# Board of Zoning Adjustment Staff Report

November 2, 2015

<b>Case No:</b>	15DEVPLAN1138
<b>Project Name:</b>	Portland Avenue Presbyterian Church
<b>Location:</b>	3126, 3128, 3108, & 3106 Portland Avenue
<b>Owner(s):</b>	Grace Jenks, Portland Avenue Presbyterian Church
<b>Applicant:</b>	Owner
<b>Representative:</b>	Marv Blomquist, Blomquist Design Group
<b>Project Area/Size:</b>	2.54 acres
<b>Jurisdiction:</b>	Louisville Metro
<b>Council District:</b>	5 – Cheri Bryant Hamilton
<b>Case Manager:</b>	Sherie' Long, Landscape Architect

Attachment 3 - Site Plan

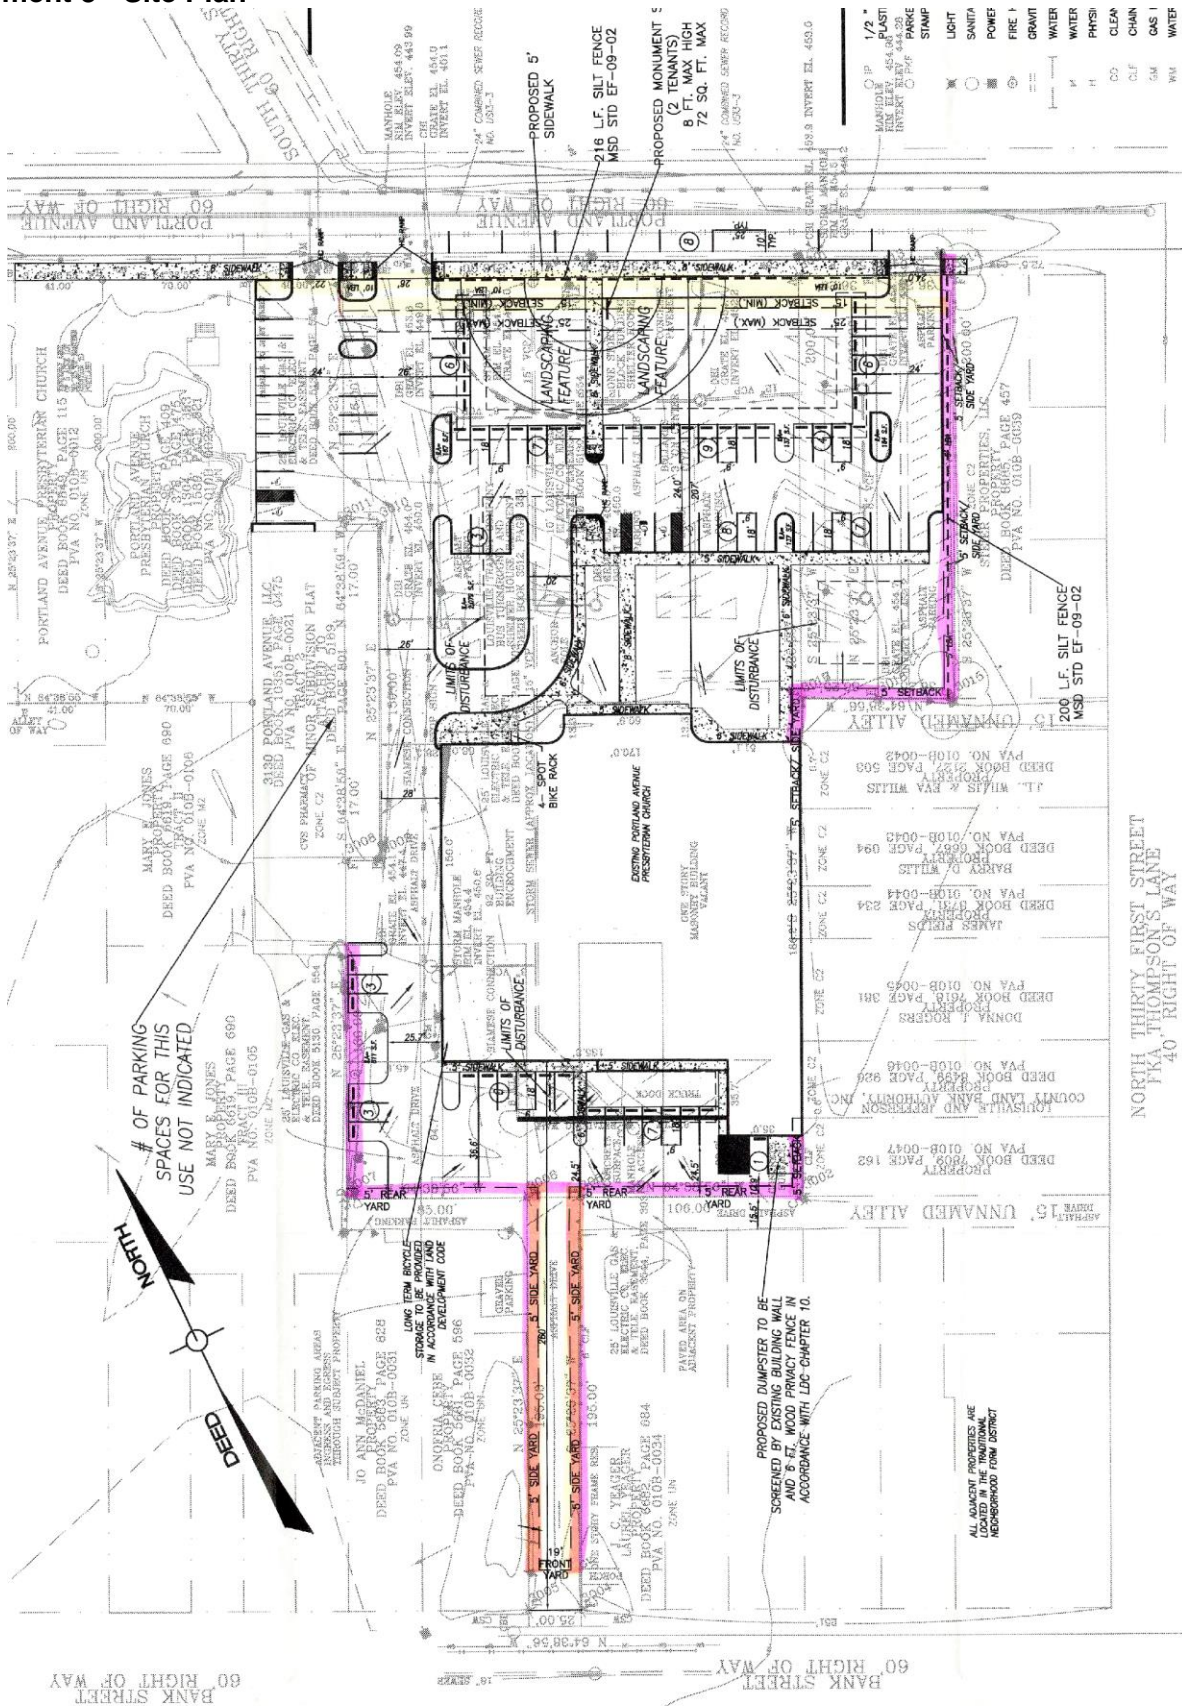
STAFF: The waiver will adversely affect adjacent property owners since no screening or tree planting is being proposed.

STAFF: The extent of waiver of the regulation is not the minimum necessary to afford relief to the applicant since no buffer is being provided along the eastern perimeter.

STAFF: The applicant has not incorporated other design measures that exceed the minimums of the district to compensate for non-compliance with the requirements to be waived. The strict application of the provisions of the regulation would not deprive the applicant of the reasonable use of the land or create an unnecessary hardship on the applicant since the proposed development can be built on the site while complying with the requirements requested to be waived.

STAFF: The extent of waiver of the regulation is not the minimum necessary to afford relief to the applicant since the parking could be modified to allow for additional green space and tree plantings to reduce the impact of the parking.

STAFF: The applicant has not incorporated other design measures that exceed the minimums of the district and compensate for non-compliance with the requirements to be waived (a net beneficial effect). The applicant could modify the parking configuration at the rear of the building to allow for additional green scape and tree planting which could provide a net benefit.

STAFF: The extent of waiver of the regulation is not the minimum necessary to afford relief to the applicant since a request to allow an encroachment of the proposed pavement could have been sought instead of eliminate of the entire requirement.

STAFF: The applicant has not incorporated other design measures that exceed the minimums of the district to compensate for non-compliance with the requirements to be waived. The strict application of the provisions of the regulation would not deprive the applicant of the reasonable use of the land or create an unnecessary hardship on the applicant since the proposed development can be built on the site while complying with the requirements requested to be waived.

STAFF: The requested variance will alter the essential character of the general vicinity since the setbacks of the other structures along the block are maintaining a more uniform distance from the street right-of-way. Plus the existing parking lot could be setback the required 15' still allowing the development to be constructed as proposed.

STAFF: The requested variance will allow an unreasonable circumvention of the zoning regulation since the parking could be modified to not encroach into the required 15' front yard setback.

STAFF: The requested variance does not arise from special circumstances that do not generally apply to land in the general vicinity or the same zone. The proposal is to modify the existing parking configuration by removing the existing pavement and restriping the lot. The configuration of the parking lot could be adjusted 5' to accommodate the required 15' front yard setback while still allowing the same number of parking spaces.

However, elimination of the eastern and western LBA areas are not in keeping with the guidelines of the comprehensive plan. The 5' LBAs could be provided along both perimeters even with parking encroaching into the western perimeter. (Waivers #3 and #6)

The parking proposed along the rear of the building could also be reconfigured to use the alley pavement for maneuvering which allows plantings to be added next to the building. Also the removal of the excess pavement will enhance the area and reduce the impact of this additional parking on the residential properties adjacent to the site. (Waiver #5)

Allowing the parking to encroach into the front setback is not supported. Since the entire parking lot is being reconfigured to add additional green space and tree/shrub plantings, the parking lot configuration could be modified to remove the parking from the front setback which is more in keeping to the existing pattern of setback along the block face. (Variance #1)
